**Re: Defect Information Report – Supplemental Report No. 6
09V-011, FL-544, Transmission Vehicle Interface Module**

Subject: RECALL 09V-011 – Transmission Vehicle Interface Module Replacement

MODEL: HDX, 3000 SERIES TRANSMISSION
SUBJECT: TRANSMISSION VEHICLE INTERFACE MODULE (VIM) REPLACEMENT
DATE: OCTOBER 7, 2009
PAGE: 1 OF 3

Figure 1

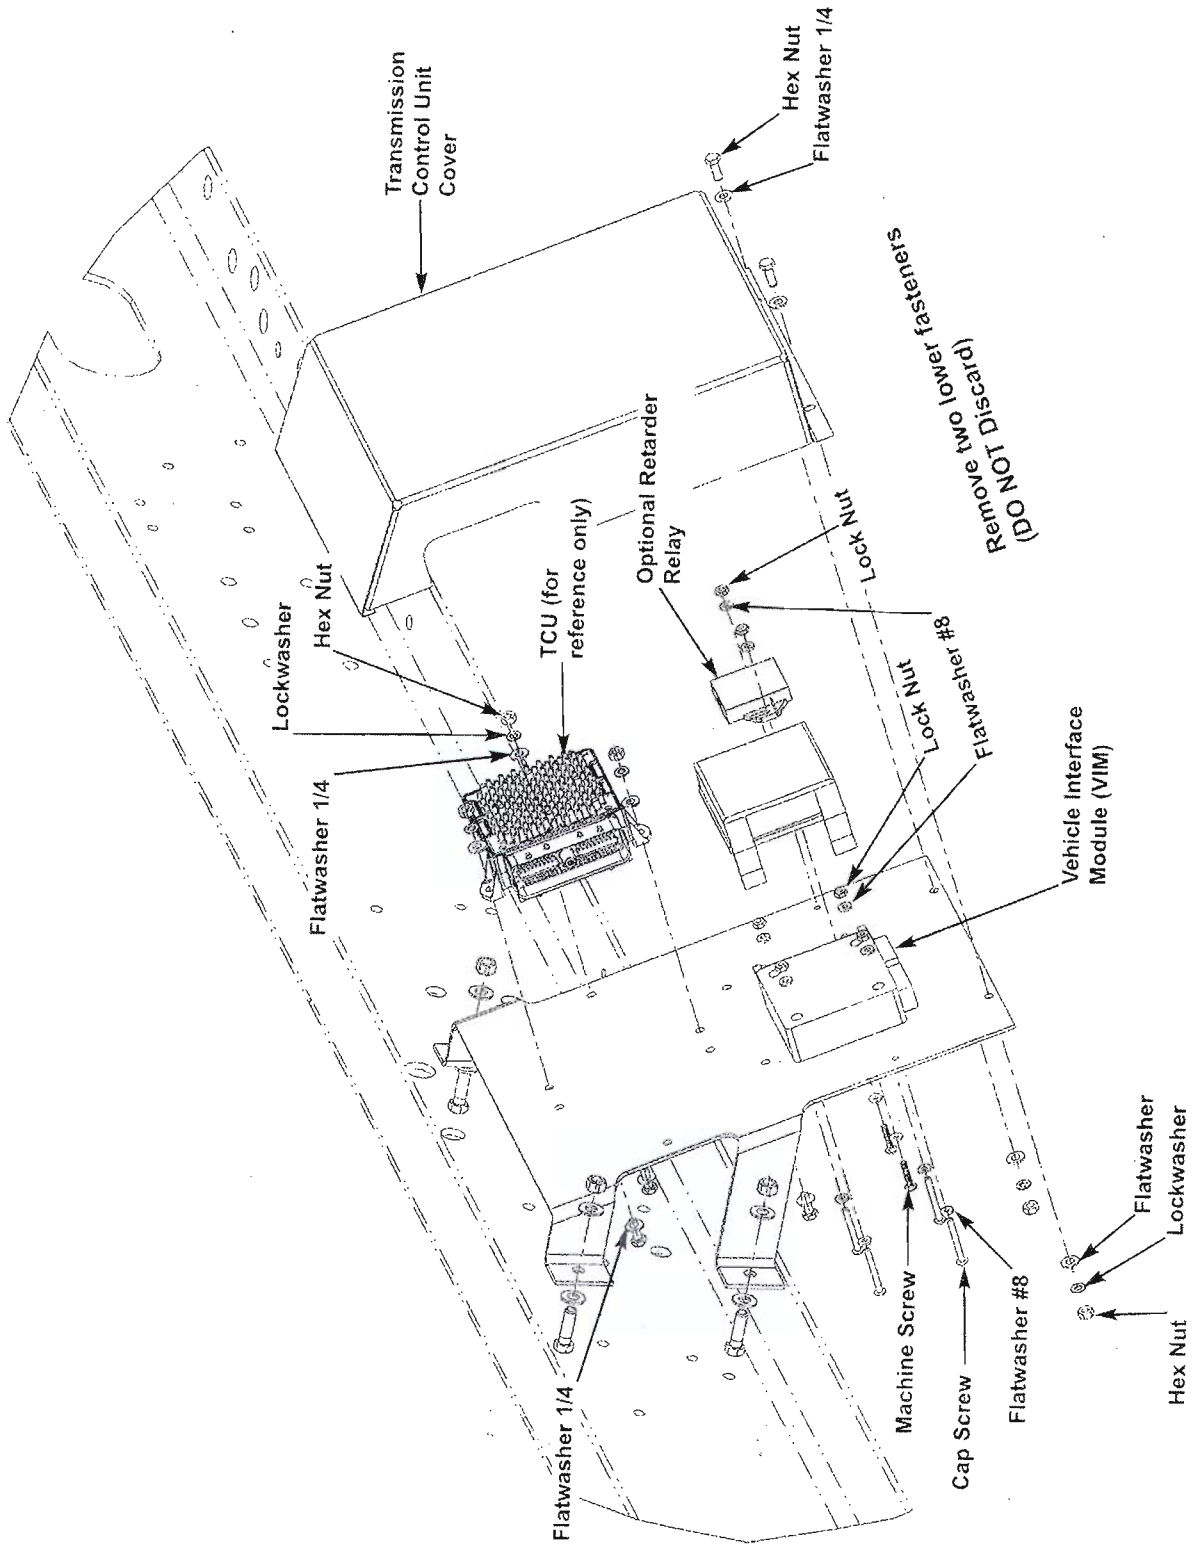
1. Set parking brake.
2. Disconnect battery cable; chock rear wheels.
3. Over the Front Axle inside the Frame area, remove the TCU Cover by removing the two (2) lower 1/4 fasteners, (Hex Bolt, Flatwasher, Lockwasher, and Hex Nut). **Retain these fasteners for reuse.** Swing upward to access inside. **Figure 1**

4. Remove the old VIM by loosening the four (4) fasteners (Machine Screw, Cap Screw, Flatwasher #8, and Lock Nut. (Discard the Lock Nut, **only**). Install the new VIM, #TBB 61202076 using the previously removed fasteners and new Locknut, #TBB 61370038.

5. Inspect all connectors prior to installing new VIM. Replace with two (2) new 10-Amp Fuses, #23-12537-010 and four (4) Relays, #TBB 61201794 supplied. (Optional Retarder and Exhaust Brake Relays may not be present.) Decal, #TBB 61202137 is also provided to install on the VIM Cover.
6. Verify vehicle operation. Replace the TCM Cover that was removed Step #3, using existing fasteners.
7. Fill the harness pass-thru with Foam Sealant, #TBB 68000901, or equivalent.

Figure 2 - Original TCU mounting until 5/21/03

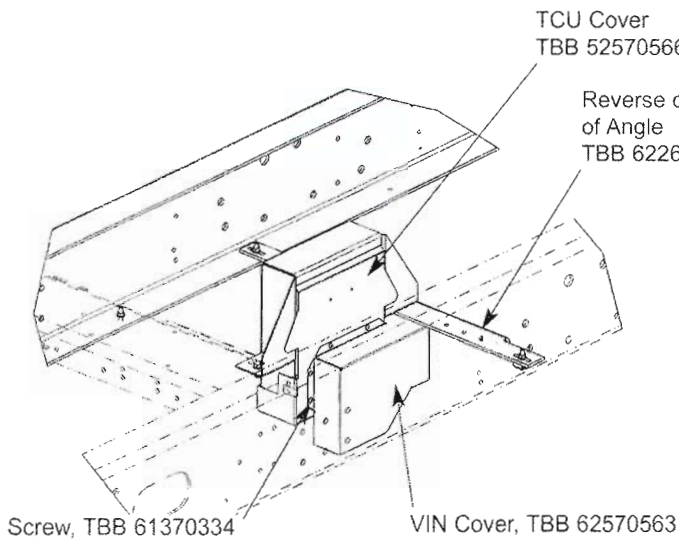
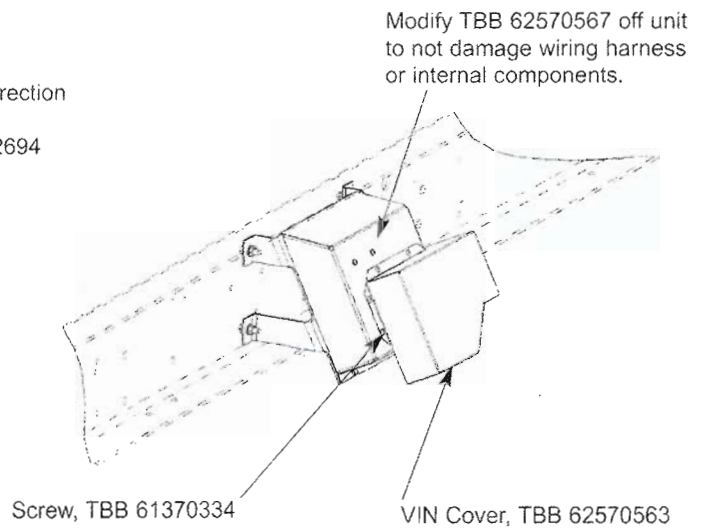
NOTE: If your unit does not have the TCM Cover, refer to PSB Index 33, Bulletin 8R which is not warrantable. Also, if the Cover is not installed as manufacturing and/or the PSB provides, the warranty on the TCU and VIM electrical will be denied on future repairs. See Figures 2 & 3 on page 3 for early configurations.
